Access Compliance Report

Public Rights-of-Way

Intersection ID: 16126	Main Street: E_W_T_HARRIS_BV	Cross Street: IDLEWILD_RD	Location: SE
ADA ID: FF31BFB9E05F	Ramp Type: Perp	Initial Pass/Fail: Fail	Overall Compliance: No
			Severity Score: 13.75

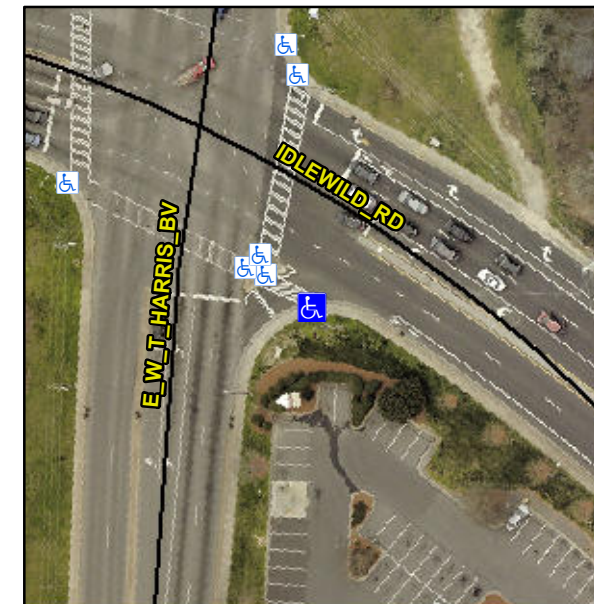
Not Found, R304.2.2, R304.5.3

Remove & Replace Entire Ramp.
